A G E N D A
FARRAGUT MUNICIPAL PLANNING COMMISSION

December 18, 2014
7:00 p.m. Farragut Town Hall

**SUBJECT: STAFF COMMENTS ON THE SITE PLAN FOR PARKING LOT
MODIFICATIONS AT THE FARRAGUT VILLAGE AT 609 N.
CAMPBELL STATION ROAD**

SUBJECT: STAFF COMMENTS ON THE SITE PLAN FOR DRAINAGE MODIFICATIONS ASSOCIATED WITH PARCELS 1.00, 1.01 AND 1.02, TAX MAP 152-C, SOUTHWEST CORNER OF KINGSTON PIKE AND CHAHO ROAD

OVERALL CONCEPTUAL SITE PLAN

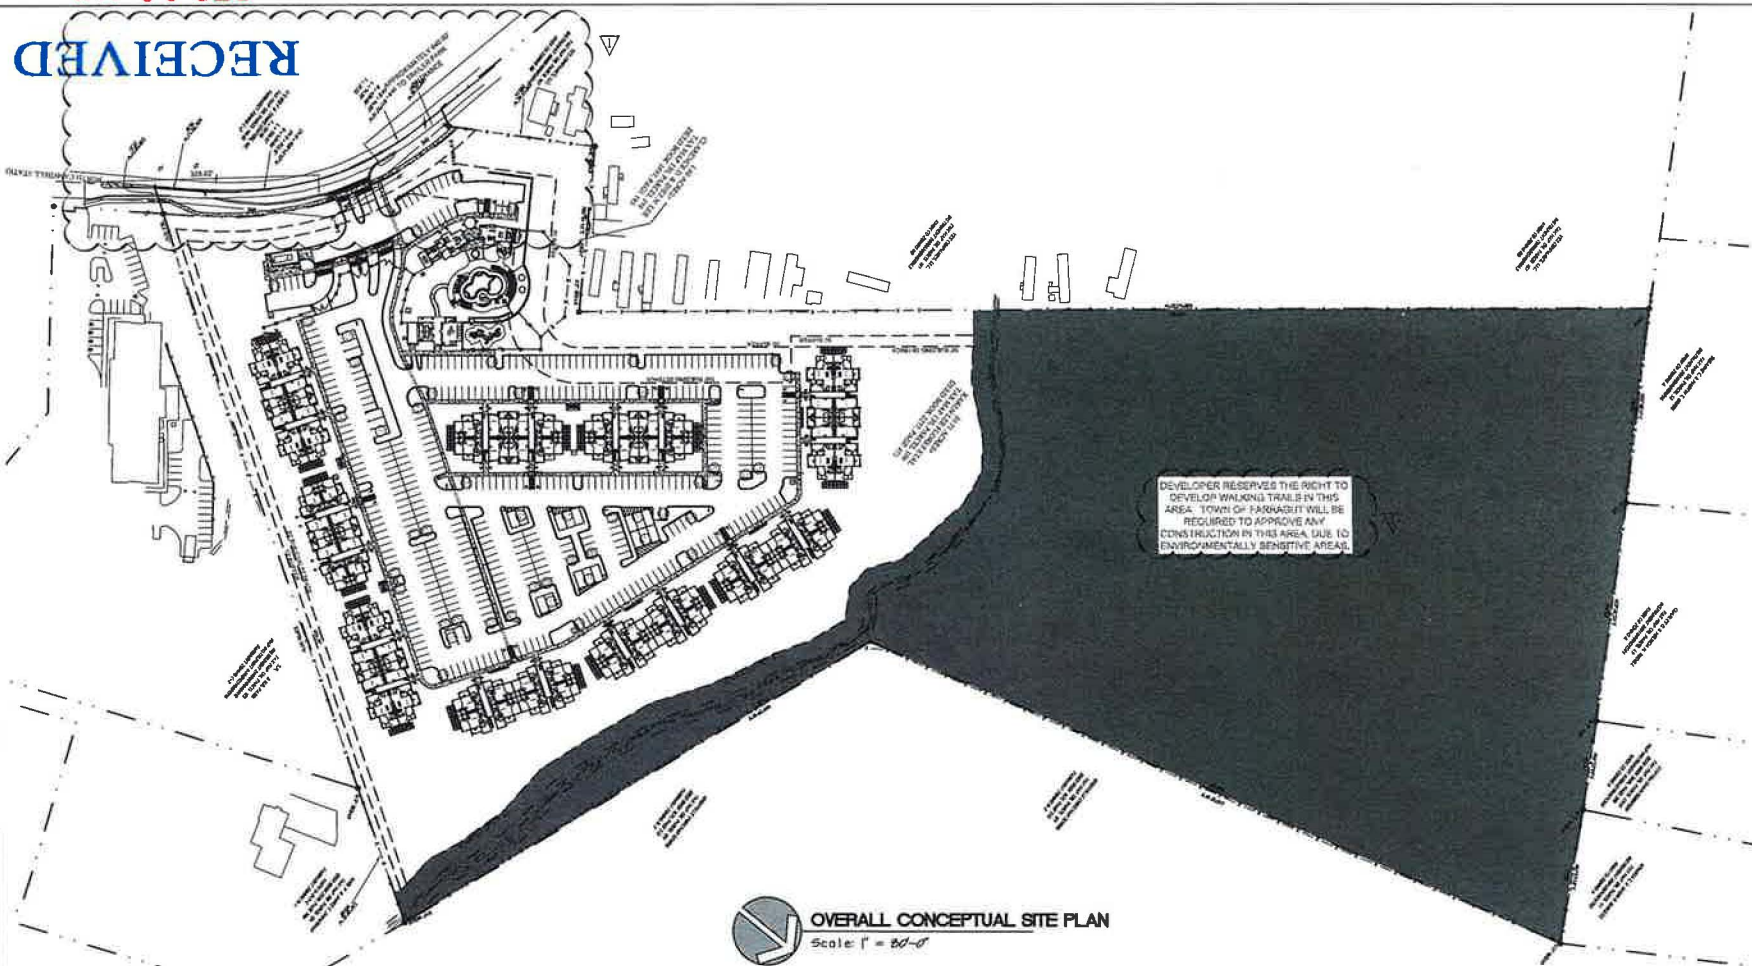
- 1) Please provide the new project name on the drawings.
- 2) An additional, remotely located, fire apparatus access road is required in accordance with D106.2 of the 2012 International Fire Code.
